ADDENDUM NO. 1  
PUBLIC WORKS ADDITIONS  
CITY OF PARAGOULD  
PARAGOULD, ARKANSAS  
Project No. 23044

September 5, 2024

The proposed Contract Documents, dated August 16, 2024, have been modified as follows:

# INSULATED DOOR - SILL

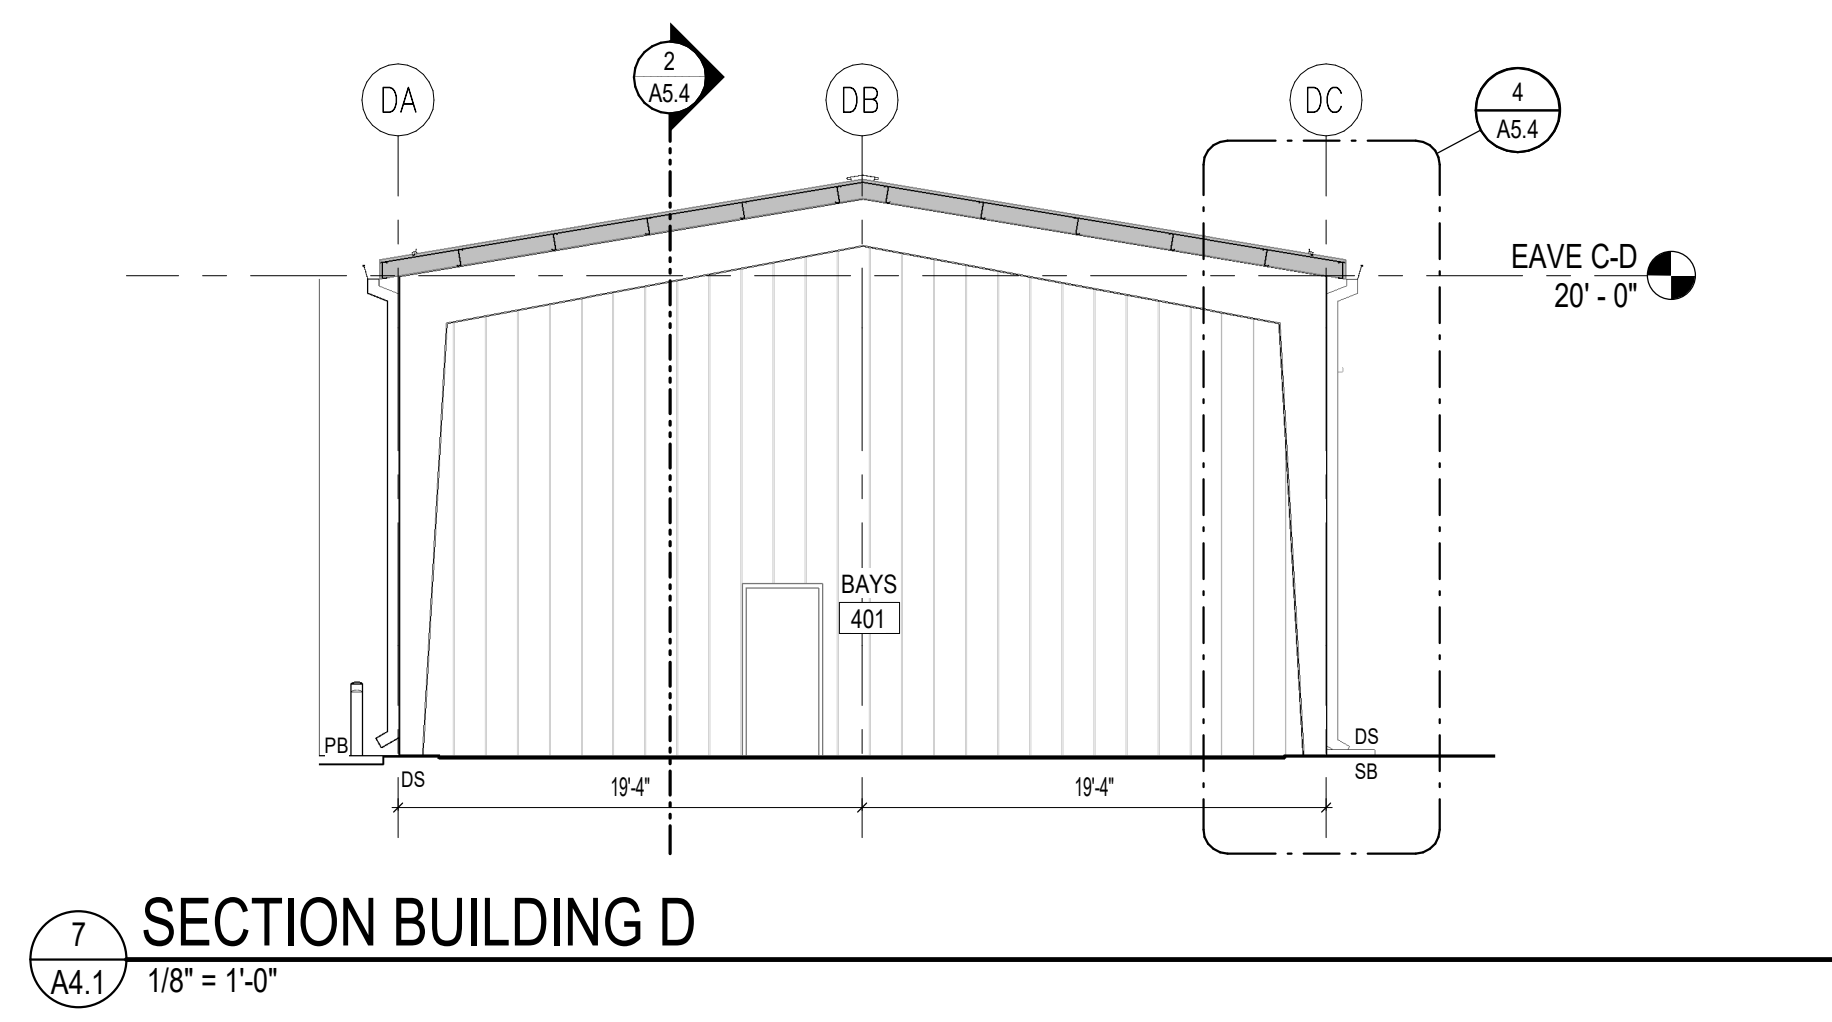
- Item #2: Sheet AD1.1 (attached): Sill detail shown for all new sectional doors with the intent to direct water away from the interior of the building.

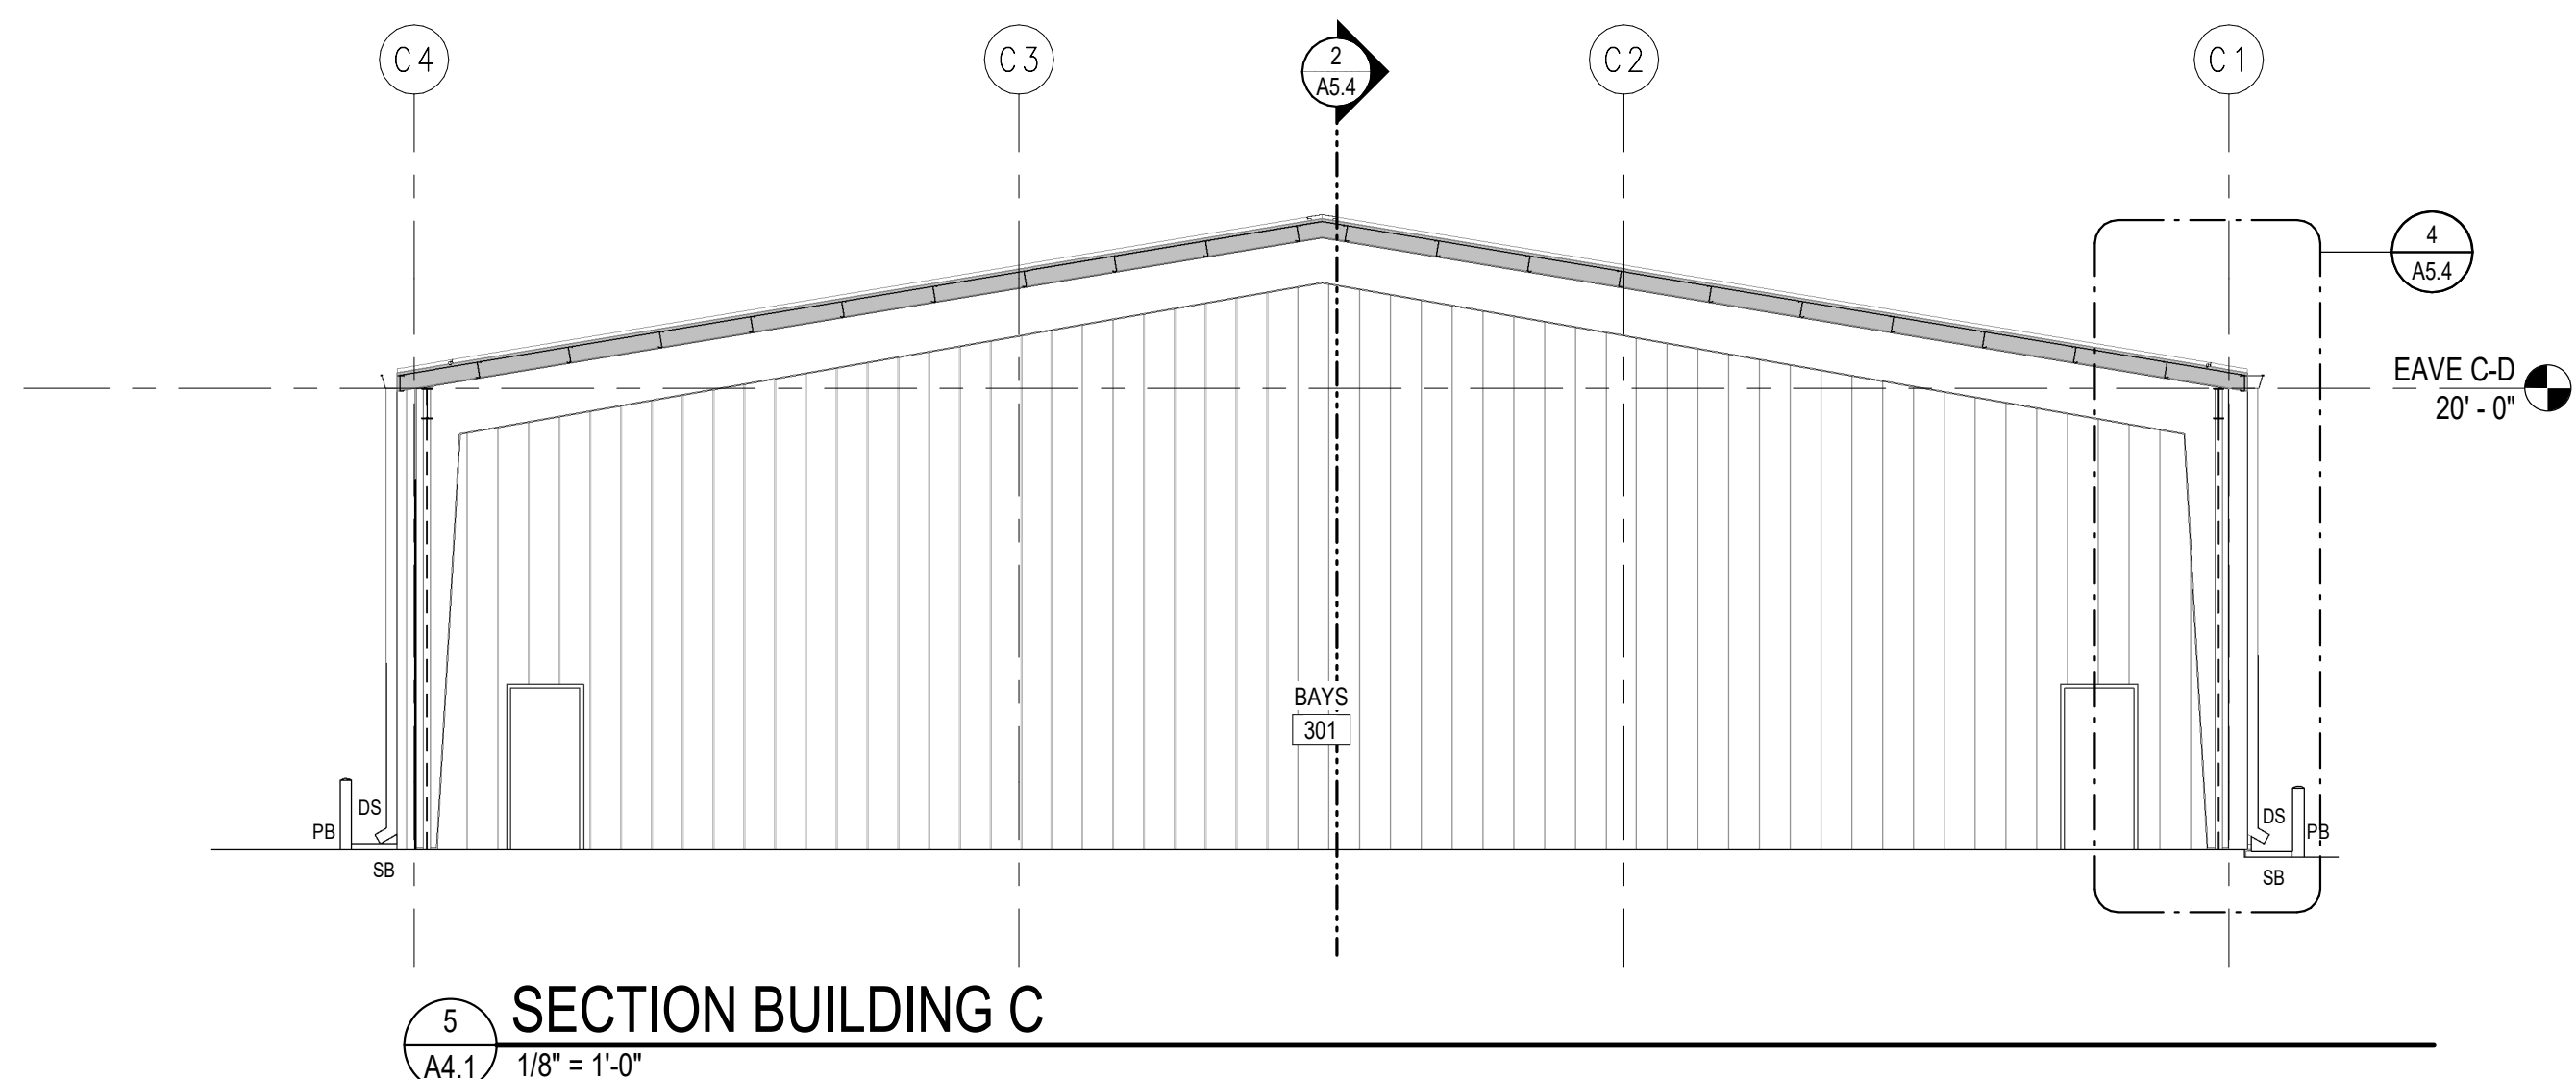
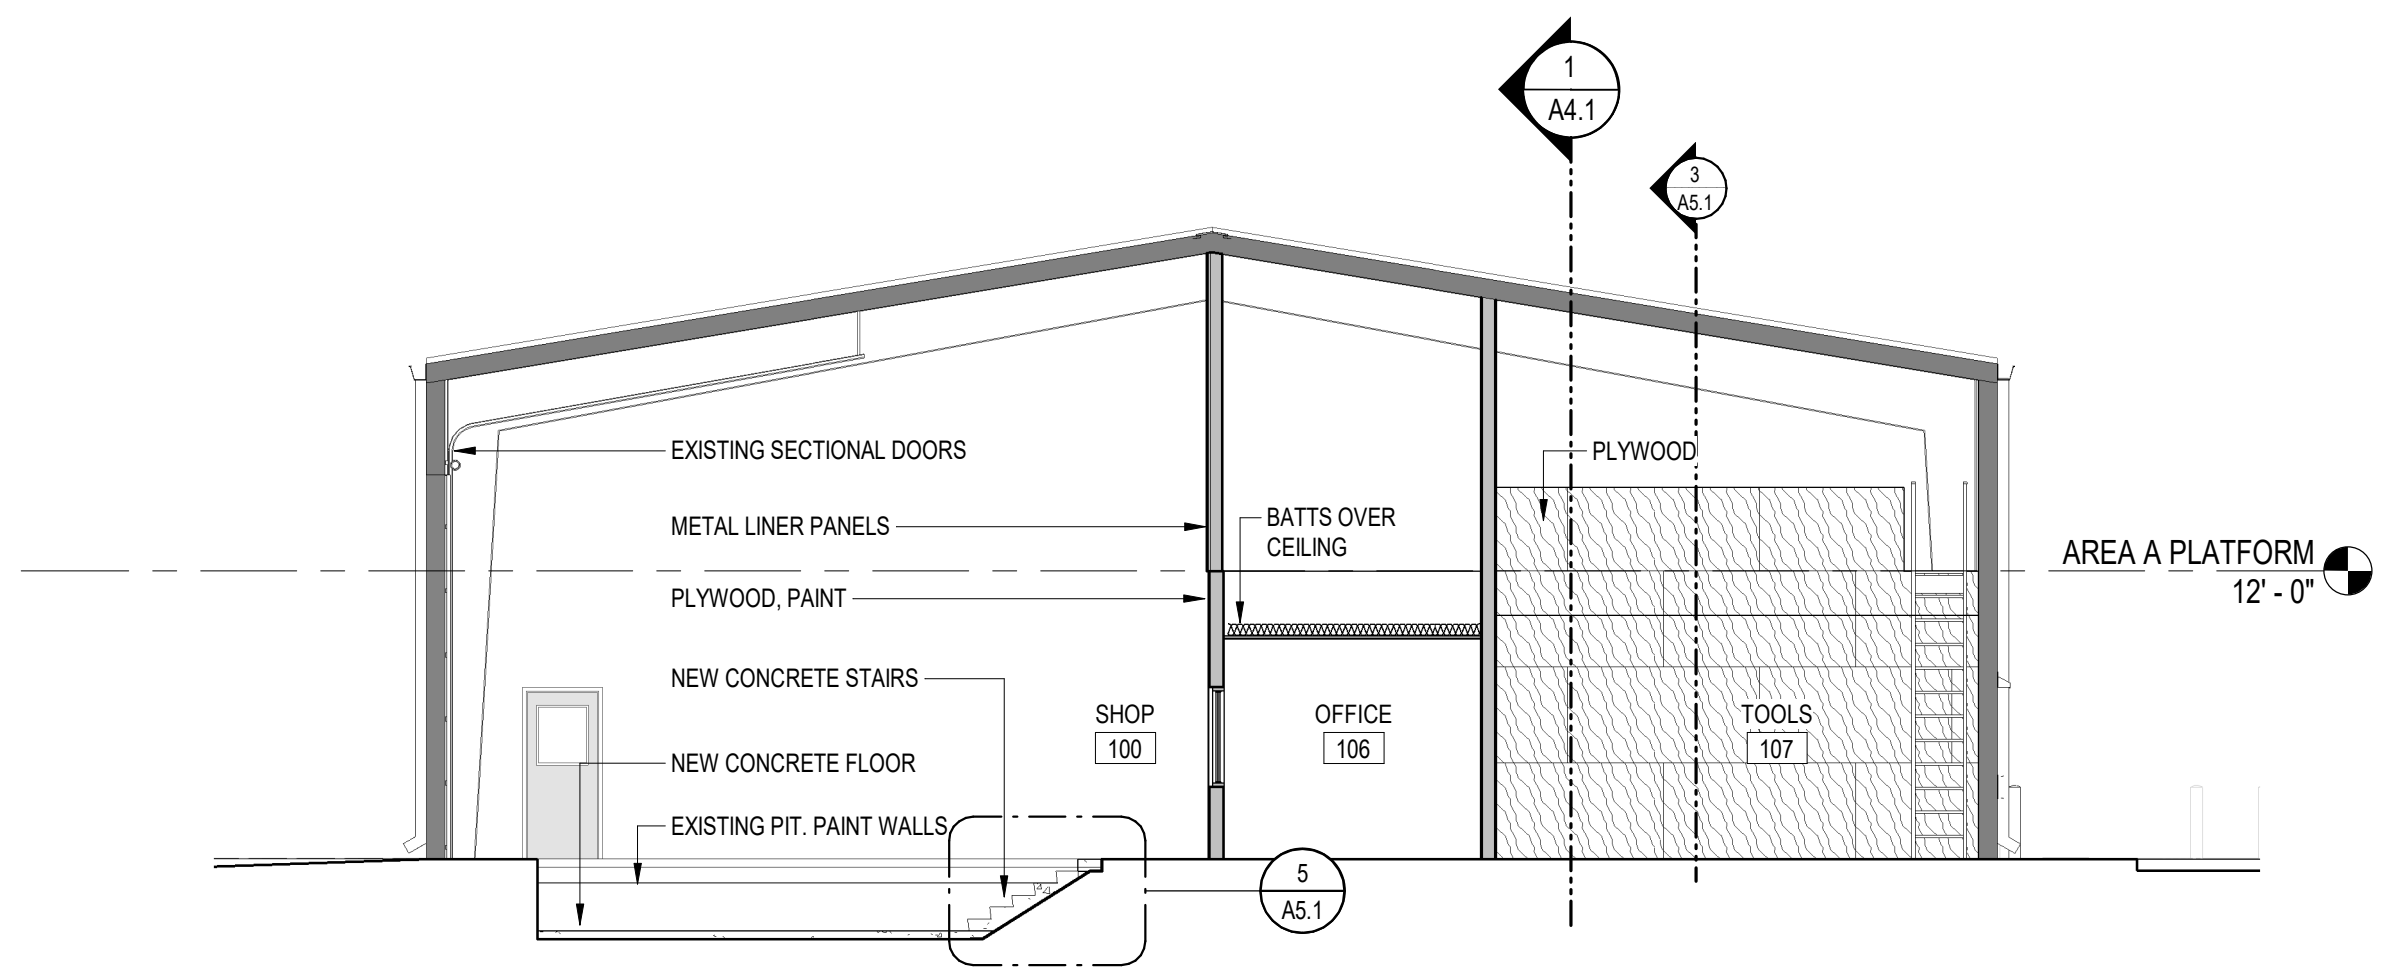
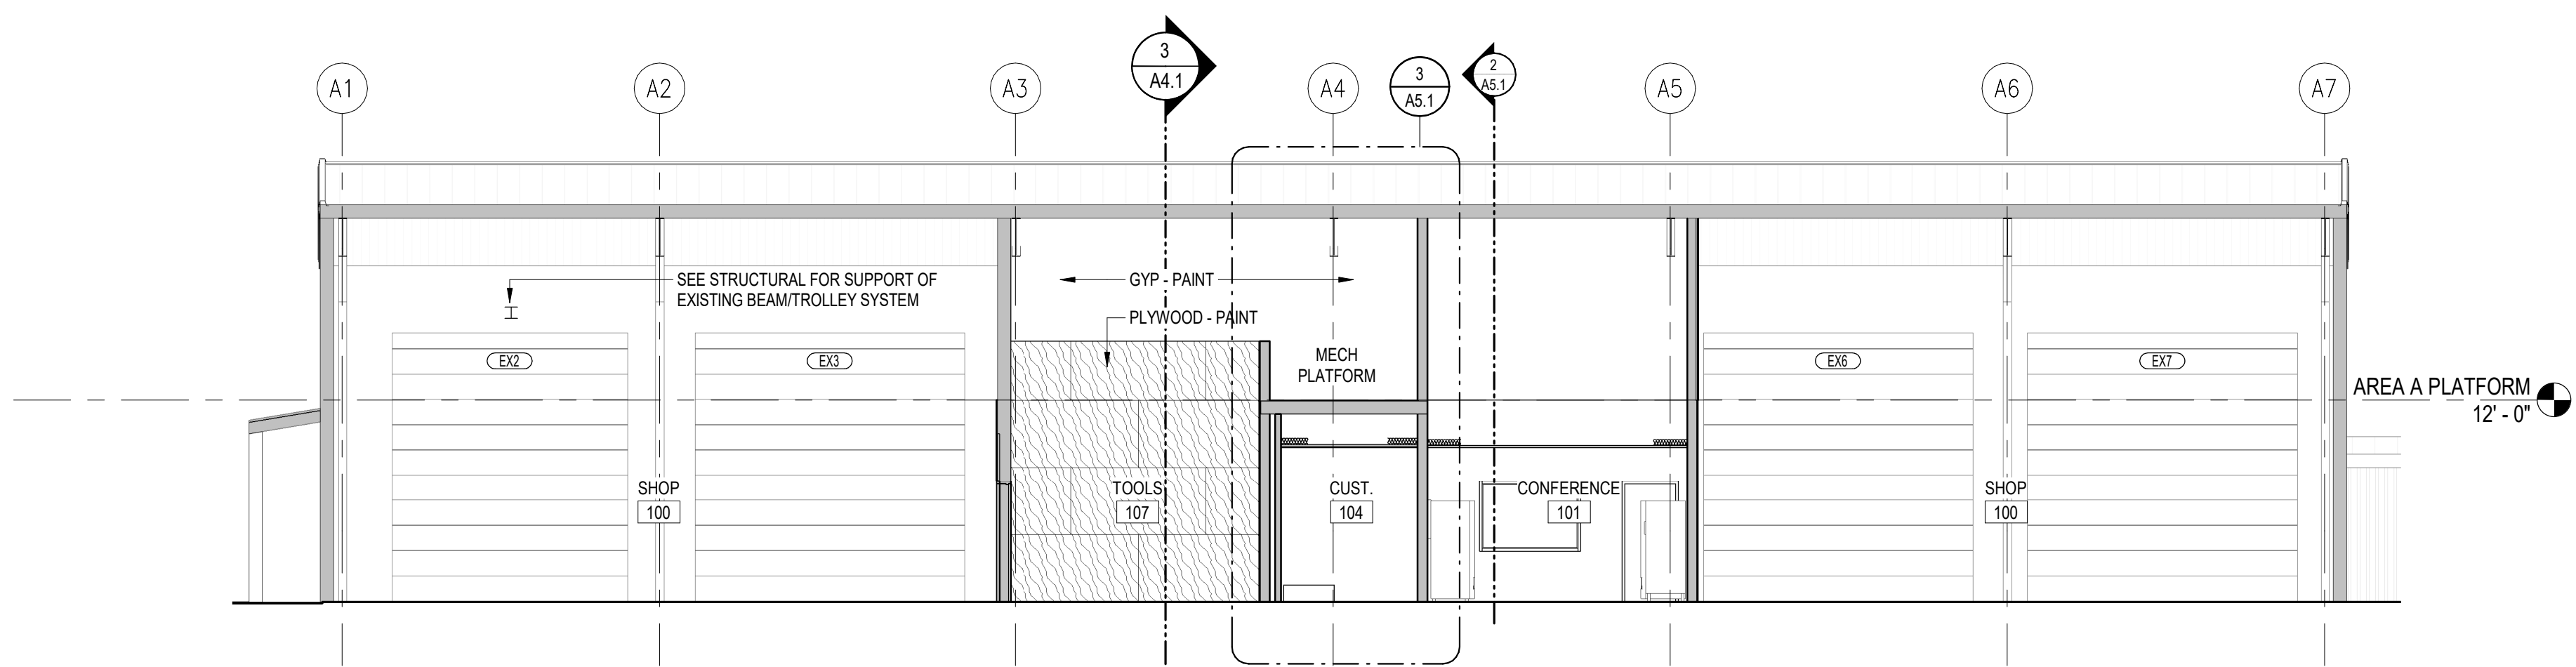
- Item #7: Sheet A4.1, Revised 2024 09-05 (attached): Revised to better show accurate and applicable wall section cut marks.
- Item #8: Sheet A8.1, Door Schedule: Door 104.1 shall be 3'-0" in width.
